Summerhill Residents Association

Item TE31.8: 1233 Yonge Street and 9 Woodlawn Avenue East

ATTACHMENT

TE31.8: 1233 Yonge Street and 9 Woodlawn Avenue East Official Plan and Zoning By-Law Amendment Application

2024 Avenue Segment Study

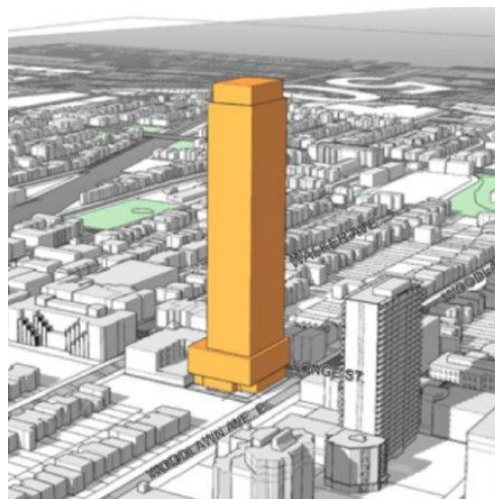
The applicant's *Avenue Segment Study* illustrates the future development of ten soft sites between Farnham and Birch with an average density of FSI 9.9 and an average height of 24.9 floors. The urban design consultant, evidently, recognized that it would be absurd to intensify the remaining soft sites with comparable locational characteristics in similar form, scale and intensity with a density of FSI 24.0 and a height of 47 floors, as called for by the Official Plan. Hence, the applicant's own study demonstrates that a density of FSI 10.0 and a height of 25 floors may, perhaps, represent a reasonable planning proposition

Mixed Use Area 'C'

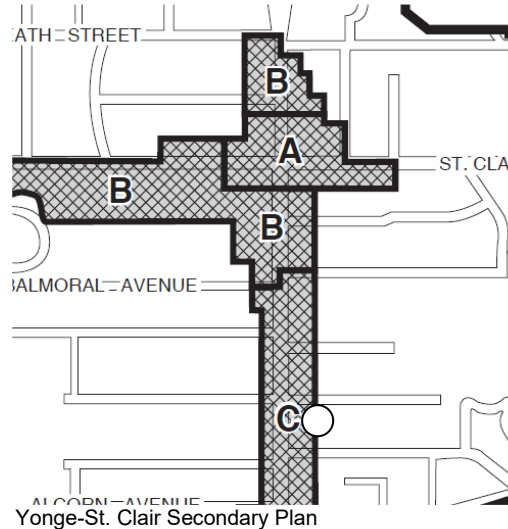
The applicant continues to maintain that planned towers in Mixed-Use Areas A and B are valid precedents, ignoring the materially different land use context, with 1233 Yonge in Mixed Use Area 'C', dwarfing the adjacent low-scale Neighbourhoods to the east and west, as opposed to relating to towers in Apartment Neighbourhoods.

Sun-Shade Study – East Side

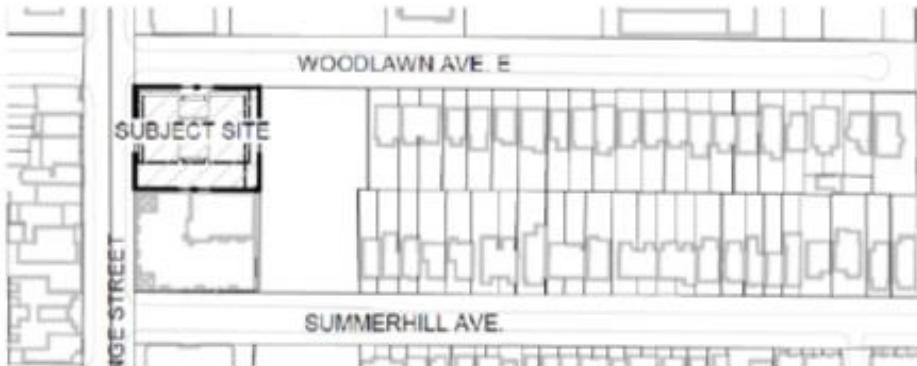
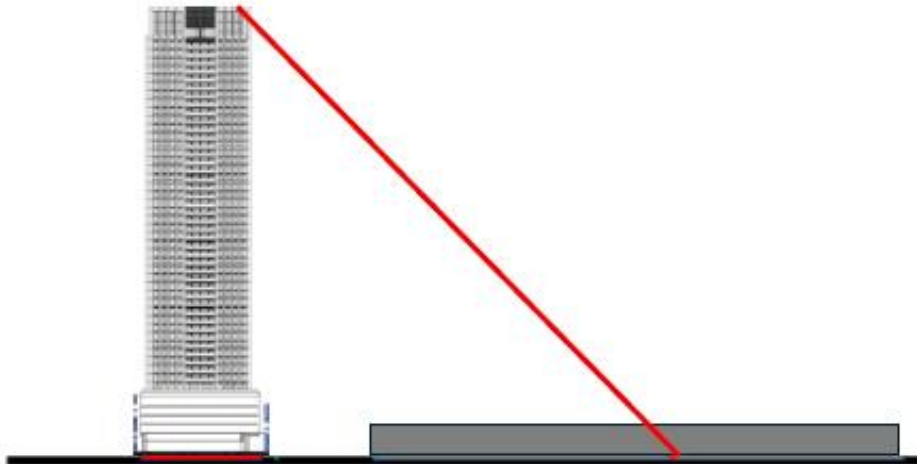
Harmonious Street Context?

OP Policy 4.5.2 (Mixed Use Areas): “In Mixed Use Areas development will: ... c) locate and mass new buildings to provide a transition between areas of different development intensity and scale, as necessary to achieve the objectives of this Plan, through means such as providing appropriate setbacks and/or a stepping down of heights, particularly towards lower scale Neighbourhoods; d) locate and mass new buildings so as to adequately limit shadow impacts on adjacent Neighbourhoods, particularly during the spring and fall equinoxes....”

45 ° Angular Plane between Tower and low-scale Neighbourhood

Precedents adjacent to Apartment Neighbourhoods? City-initiated Planning Framework: Height Peak Areas

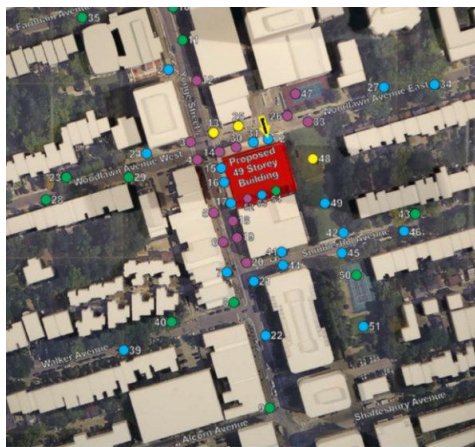
Planning Framework Policy 2 (Goals): “The Goals of the Planning Framework are to: iii) Appropriately transition tall building heights from a Height Peak around the Yonge St. Clair intersection downward to lower-scaled areas.”

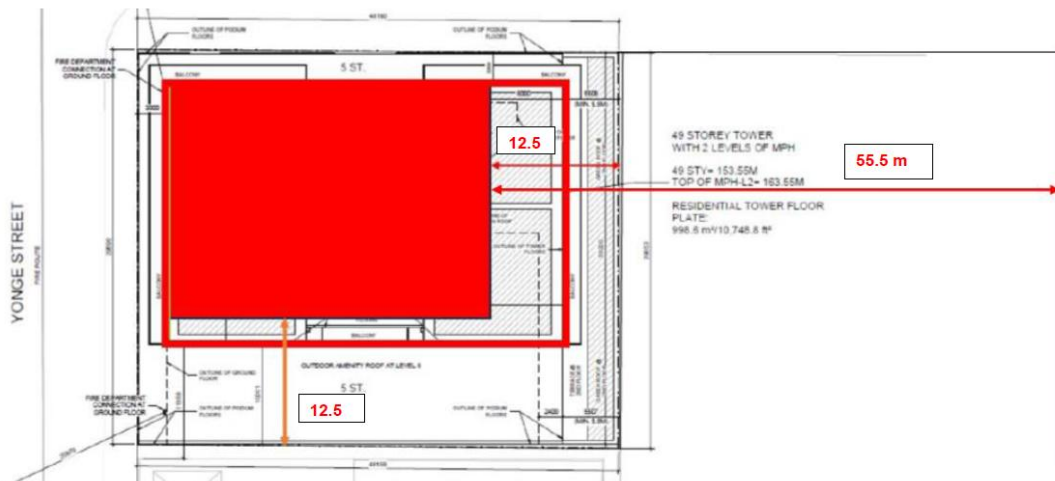
The proposed tower floor plate is 1,007 m² or 34% greater than the maximum of 750 m² recommended by the TBDG on a tiny site of 0.19 ha. Both the Official Plan and TBDG call for the transition in scale to be accommodated on the development site itself. Increasing the minimum tower setback on the east from 6.0 m to the recommended minimum of 12.5 m and the tower setback to the south from the proposed 10.0 m to the recommended minimum of 12.5 m would reduce the floor plate from the proposed 1,007 m² to a more reasonable 750 m², as called for by the TBDG.
